# MARTIN COUNTY, FLORIDA DEVELOPMENT REVIEW

## STAFF REPORT

## **I-95 RIVERSIDE PUD PHASE IV PLAT A/K/A Pulte I-95 (Camellia)**

This is a request by HJA Design Studio, LLC, on behalf of Pulte Home Company, LLC, for approval of the 95 Riverside PUD Phase IV Plat. The Plat is to be consistent with the Phase IV Final Site Plan which contains 98 single-family townhomes on an approximately 12.40-acre site. The 95 Riverside PUD is located on the north side of SW Kanner Hwy / SR 76, on SW Lost River Road, approximately 0.17 miles east of the I-95 interchange in Stuart. Included is a request for a Certificate of Public Facilities Exemption.

JOB # 9611
SHT.NO. 2
OF 6 SHEETS

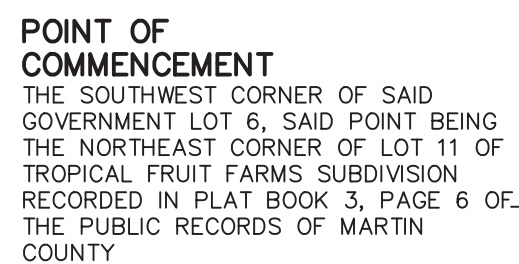
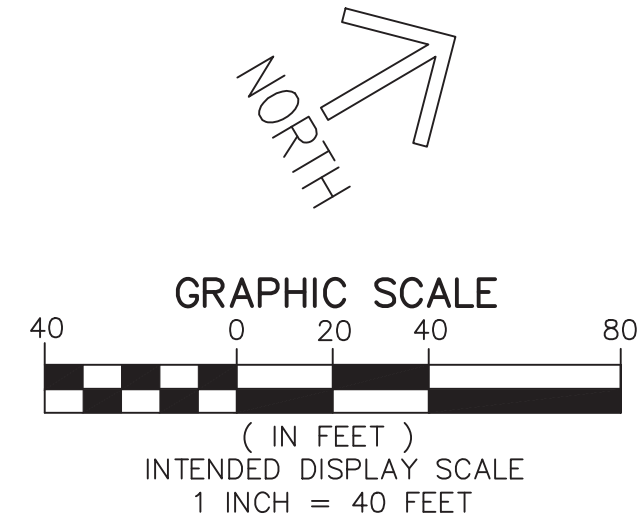
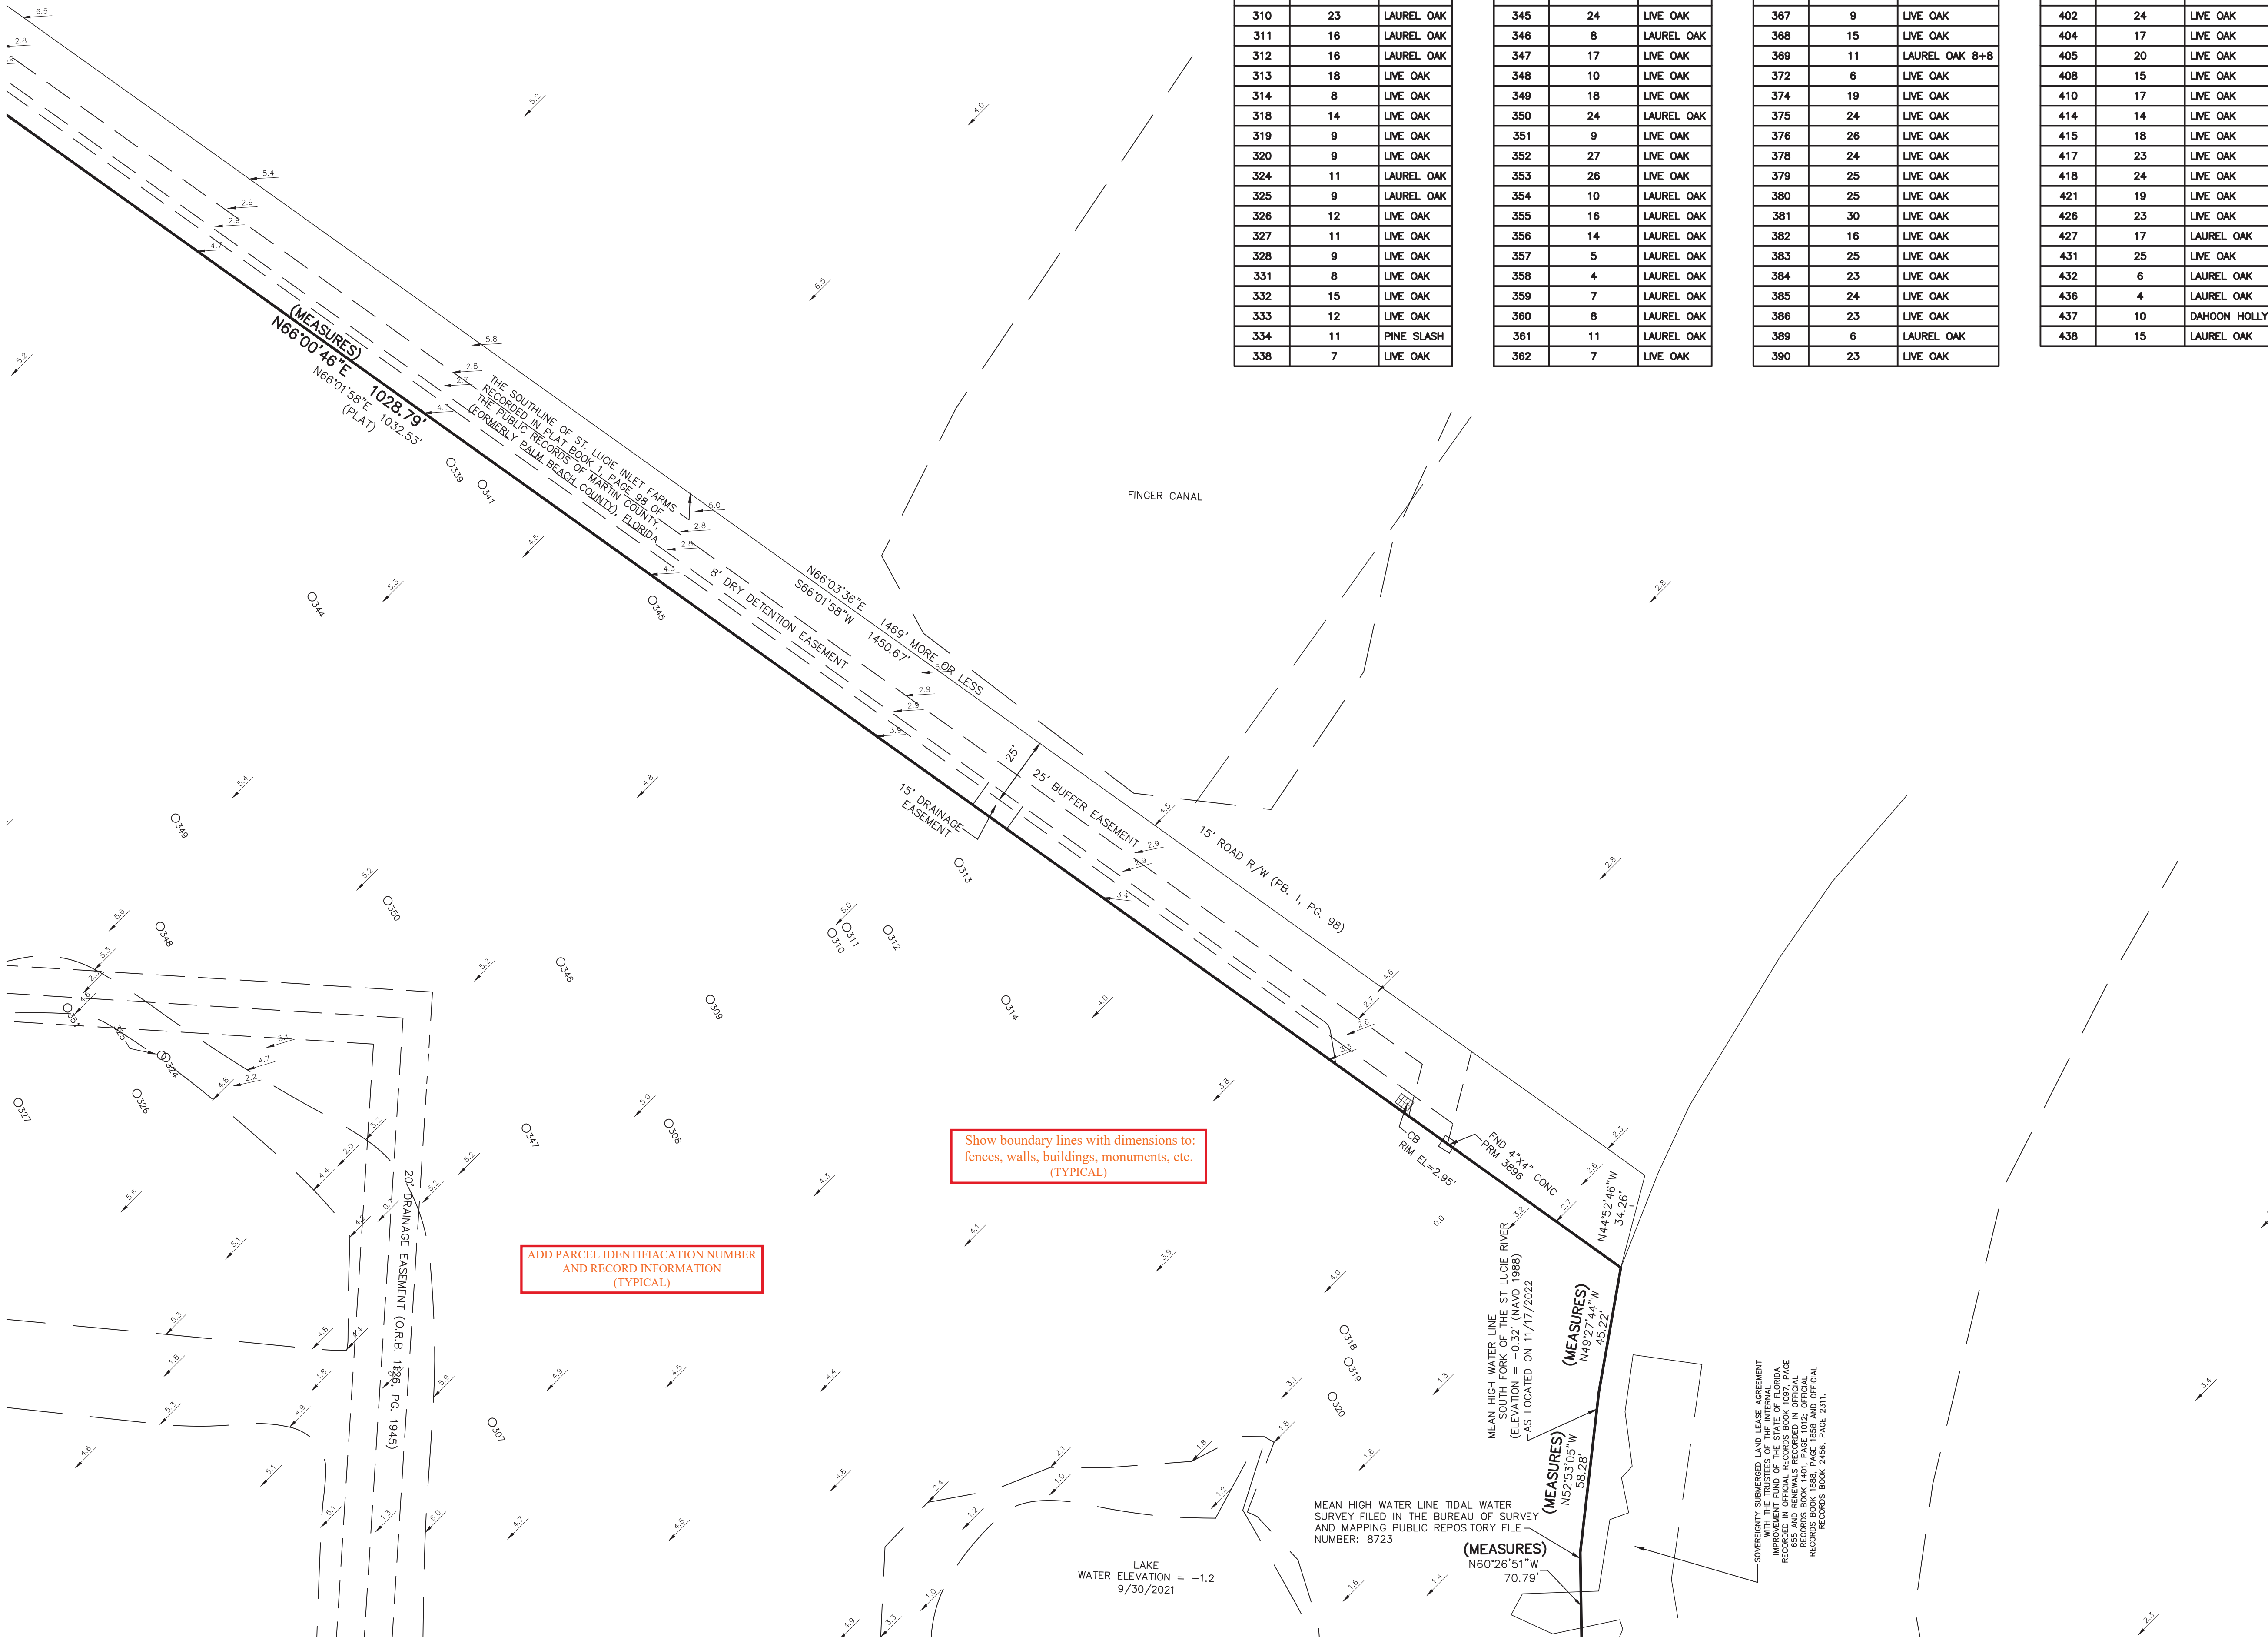
ADD PARCEL IDENTIFIACATION NUMBER  
AND RECORD INFORMATION  
(TYPICAL)

Show boundary lines with dimensions to fences, walls, buildings, monuments, etc.  
(TYPICAL)

1. REMOVE ALL TREE AND VERTICAL INFORMATION FROM THE SURVEY FOR CLARITY. (TYPICAL)
2. REMOVE ALL UNNECESSARY PORTIONS OF THE SURVEY AND RESTRICT IT TO ONLY THE SUBJECT PROPERTY. (TYPICAL)
3. REFER TO THE SITE PLAN, LABEL EASEMENTS TO BE ABANDONED, AND ADD A RECORD PLACE HOLDER UNDERNEATH SAID LABEL.

1. REMOVE ALL TREE AND VERTICAL INFORMATION FROM THE SURVEY FOR CLARITY. (TYPICAL)  
2. REMOVE ALL UNNECESSARY PORTIONS OF THE SURVEY AND RESTRICT IT TO ONLY THE SUBJECT PROPERTY. (TYPICAL)  
3. REFER TO THE SITE PLAN, LABEL EASEMENTS TO BE ABANDONED, AND ADD A RECORD PLACE HOLDER UNDERNEATH SAID LABEL.

### Phase IV - Final Site Plan

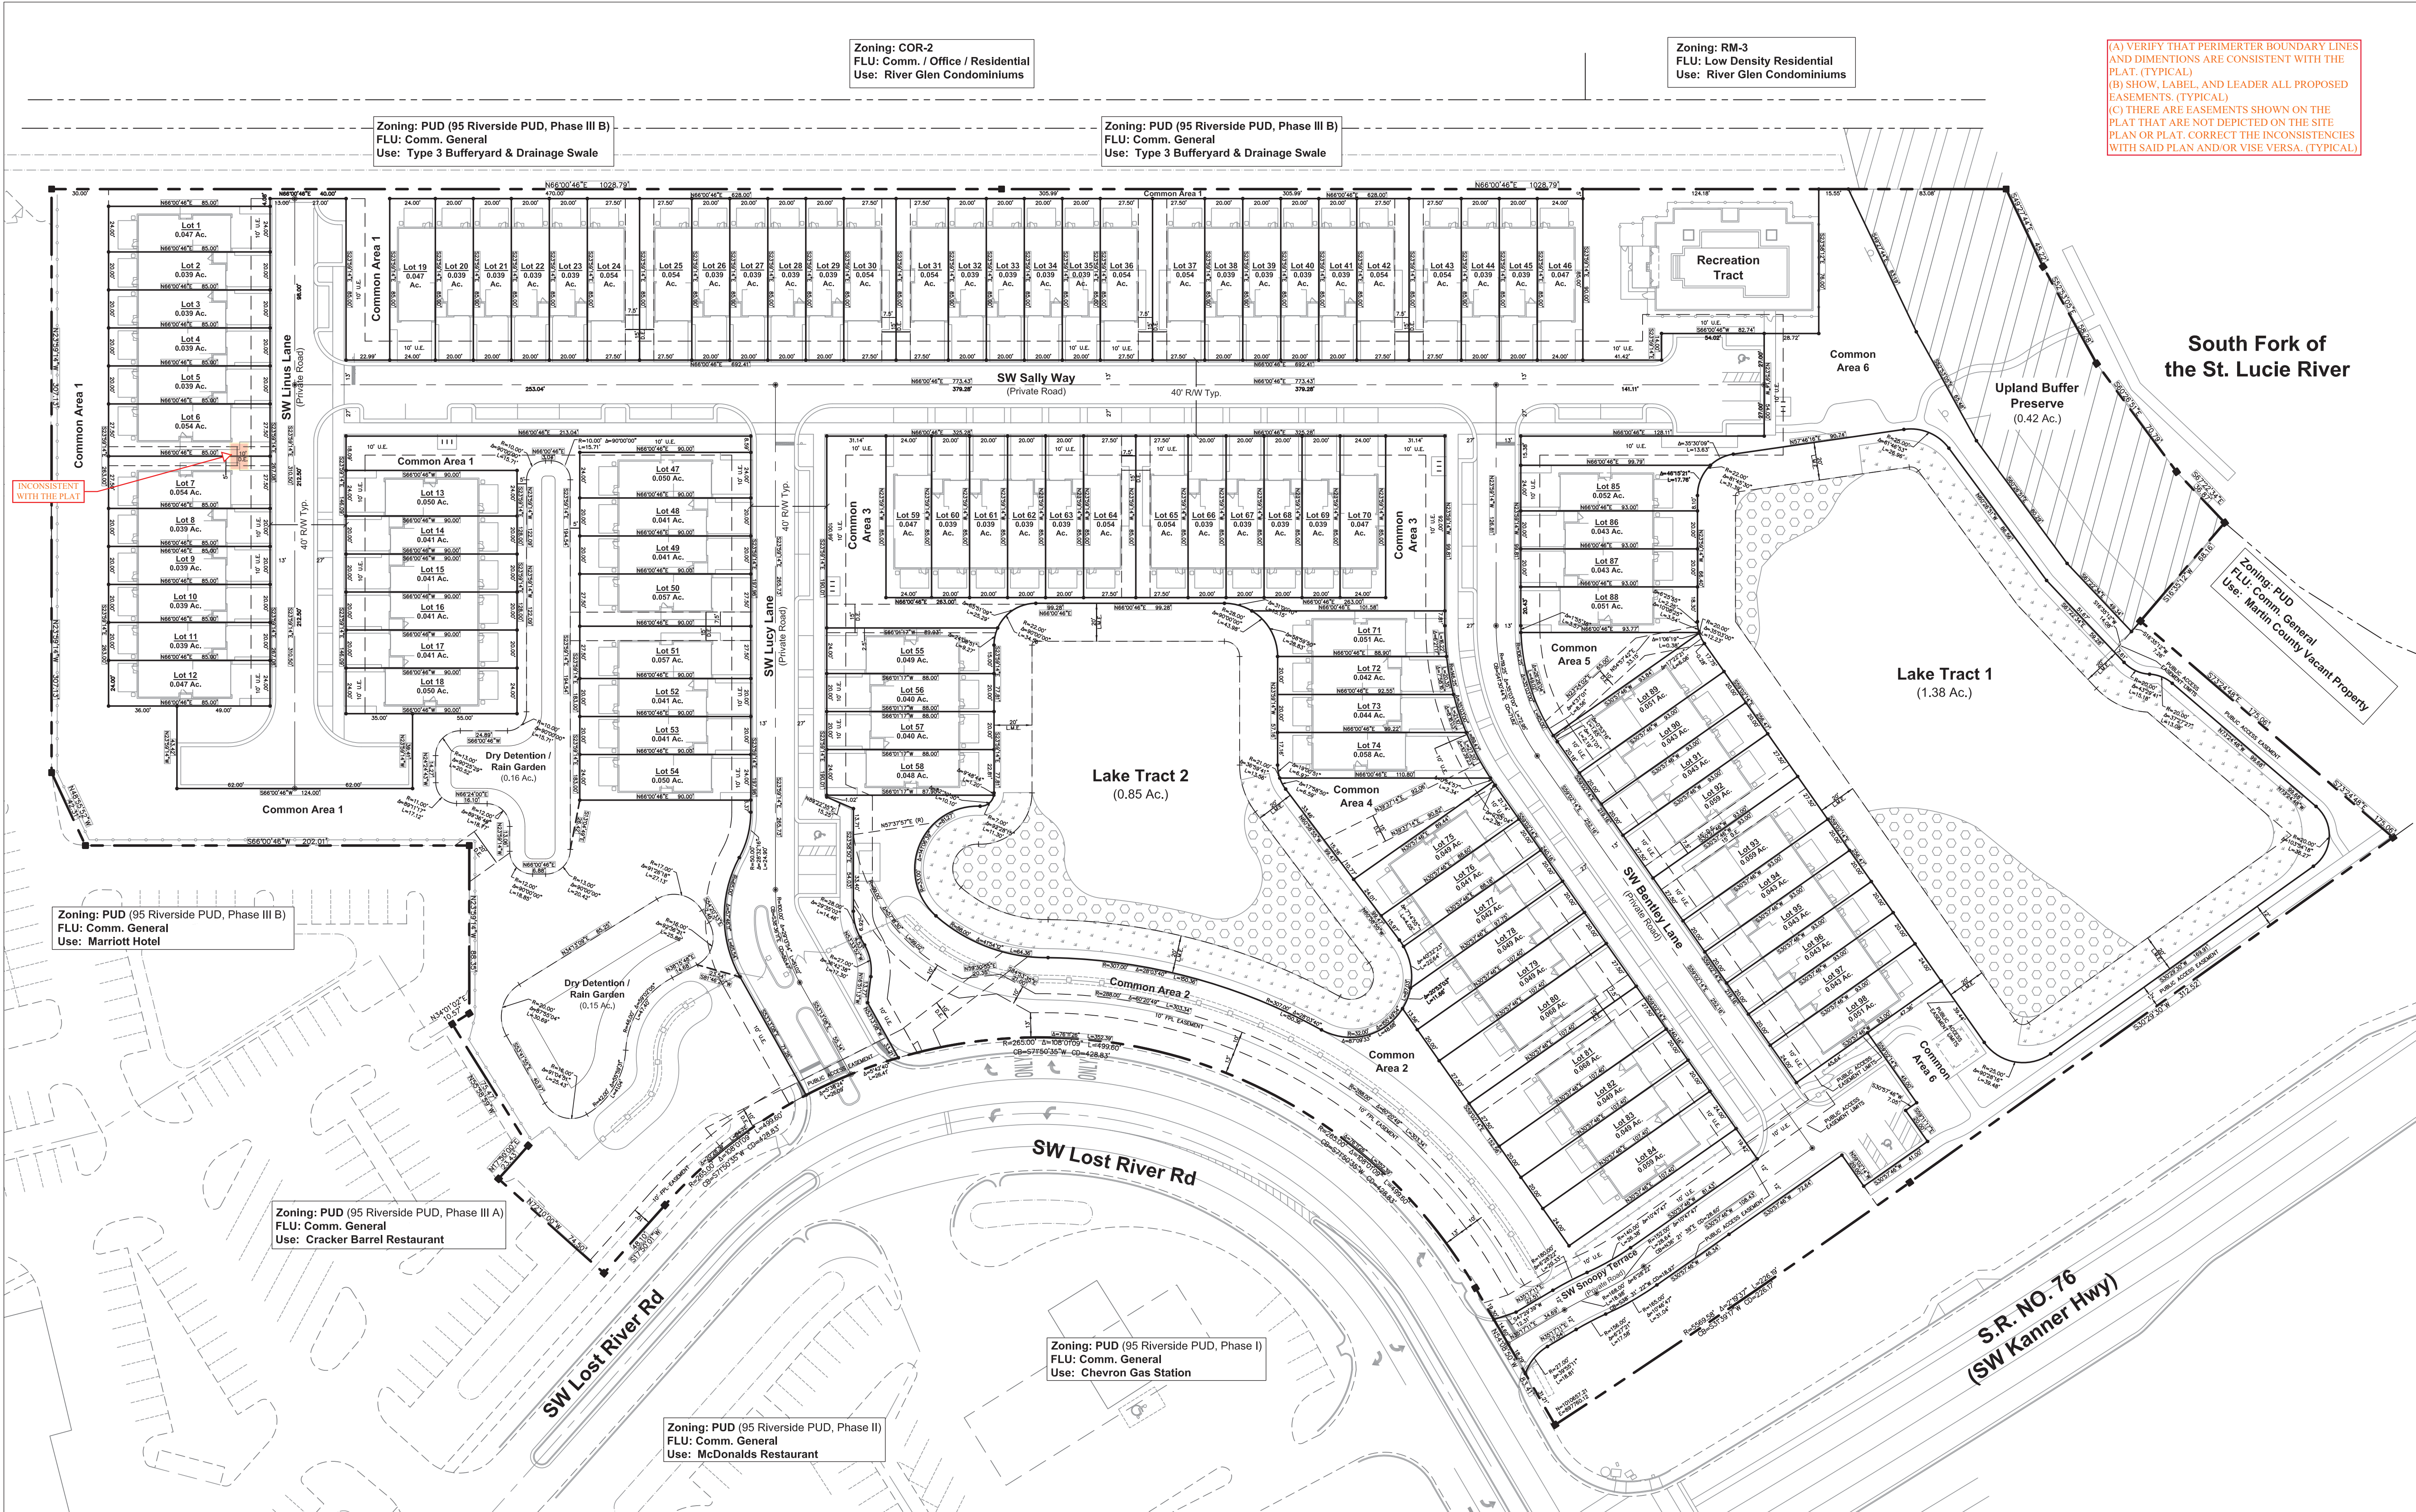
THE PLAT NAME IS INCONSISTENT WITH THE ONE ON THE SITE PLAN. REVISE SAID NAME ON THE PLAT AND/OR SAID PLAN ACCORDINGLY. (TYPICAL)

# CAMELLIA P.U.D.

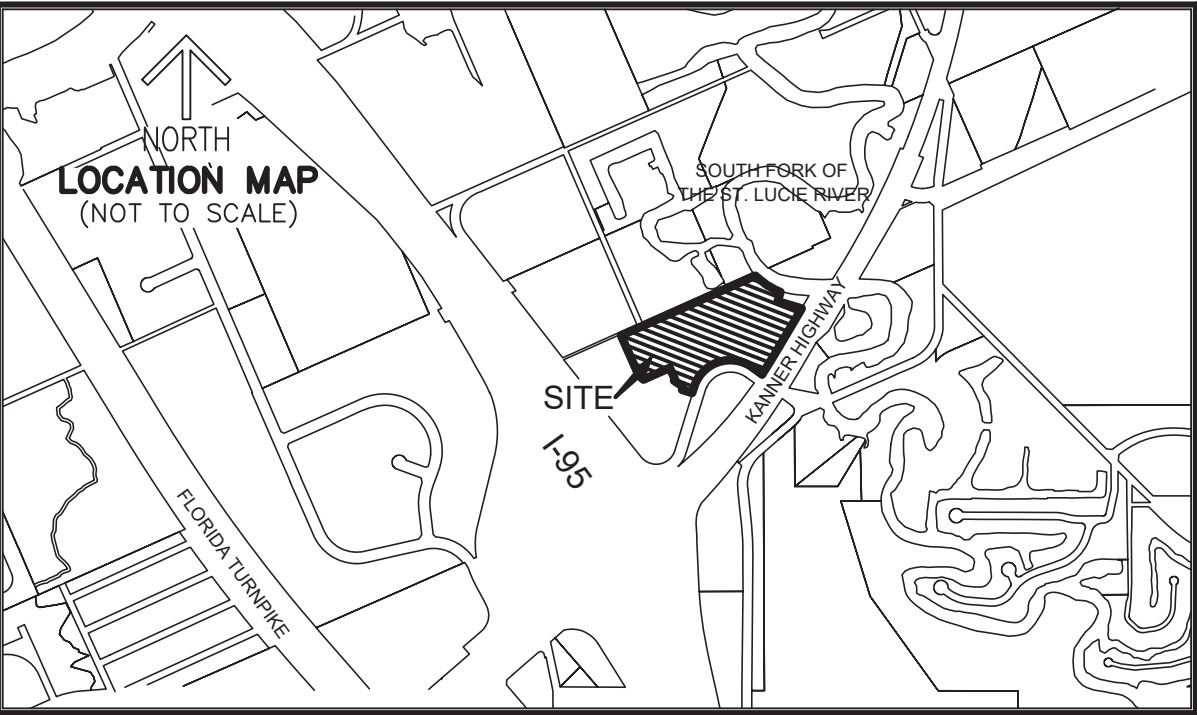
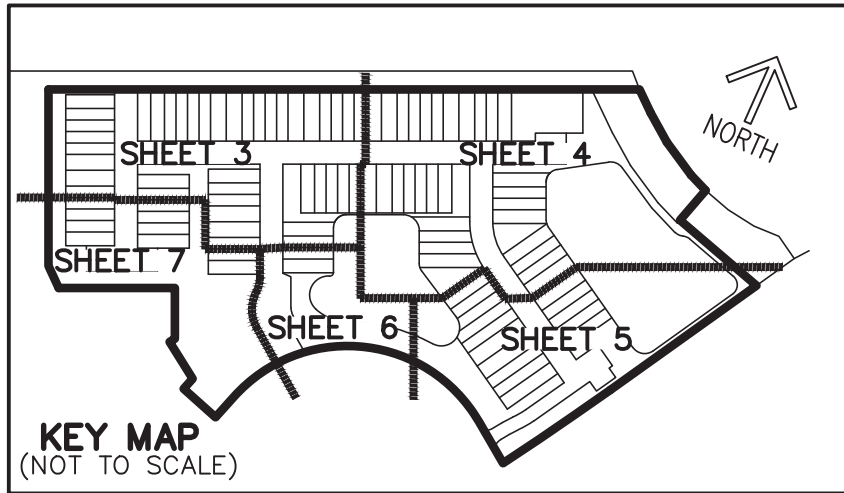
Pursuant to Ch. 177.091(28), add the following statement to the notes: "All platted utility easements shall provide that such easements shall also be easements for the construction, installation, maintenance, and operation of cable television services; provided, however, no such construction, installation, maintenance, and operation of cable television services shall interfere with the facilities and services of an electric, telephone, gas, or other public utility. In the event a cable television company damages the facilities of a public utility, it shall be solely responsible for the damages. This section shall not apply to those private easements granted to or obtained by a particular electric, telephone, gas, or other public utility. Such construction, installation, maintenance, and operation shall comply with the National Electrical Safety Code as adopted by the Florida Public Service Commission."

REFER TO RESOLUTION NUMBER 02.6.1, (BCC BK. 457, PG. 1129) AND ADD THE TITLE CERTIFICATION TO THIS SHEET. ALSO IF REQUIRED, ADD THE MORTGAGEE'S CONSENT AND ITS PUBLIC NOTARY LANGUAGE INTO THE PLAT'S DEDICATION.

CAMELLIA P.U.D.

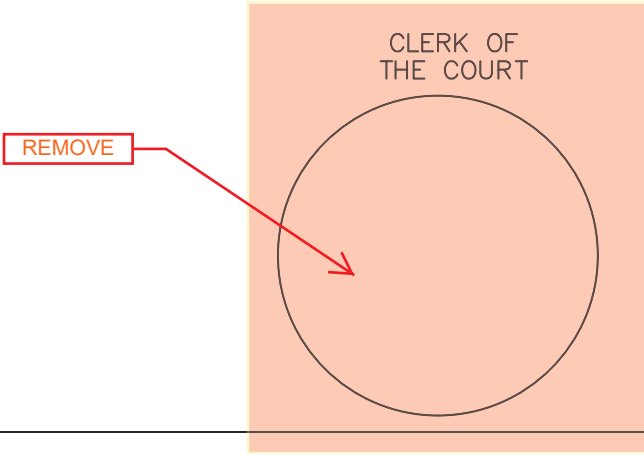
PLAT NAME IS INCONSISTENT WITH THE TITLE OF THE PLAT AS ABOVE NOTED. REVISE ACCORDINGLY AND ENSURE CONSISTENCY WITH THE SITE PLAN NAME.

THIS INSTRUMENT PREPARED BY  
RONNIE L. FURNISS  
OF  
**CAULFIELD and WHEELER, INC.**  
SURVEYORS – ENGINEERS – PLANNERS  
7900 GLADES ROAD, SUITE 100  
BOCA RATON, FLORIDA 33434 – (561)392-1991  
CERTIFICATE OF AUTHORIZATION NO. LB3591

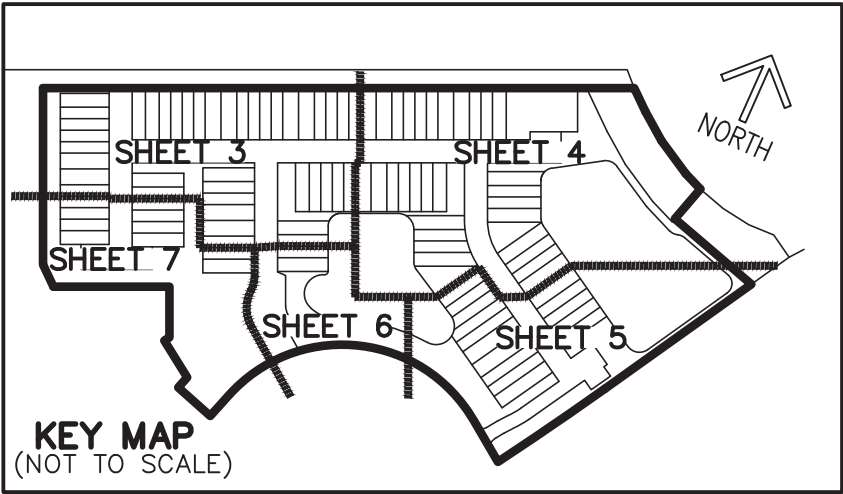
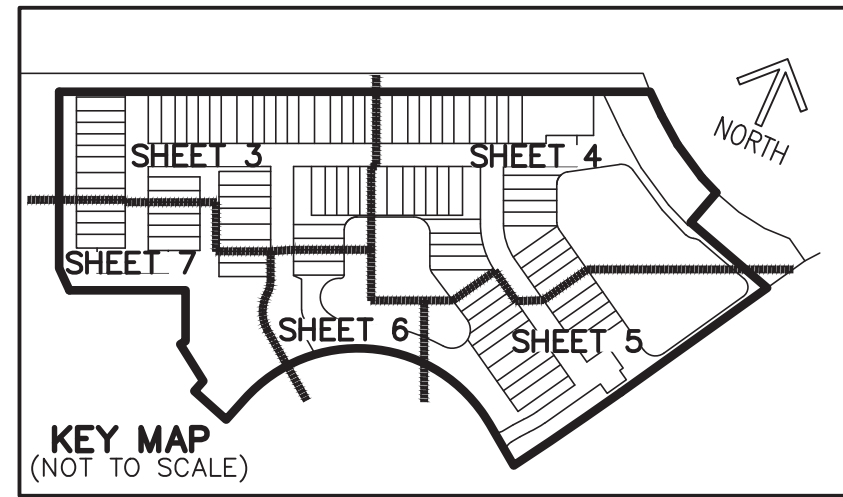
IF POSSIBLE, ELIMINATE THIS SHEET AND  
RENUMBER THE REMAINING SHEETS  
ACCORDINGLY.  
NOTE: ALL COUNTY SIGNATURES SHALL  
APPEAR ON THE FIRST PAGE.

MOVE TO SHEET ONE

MOVE TO SHEET ONE
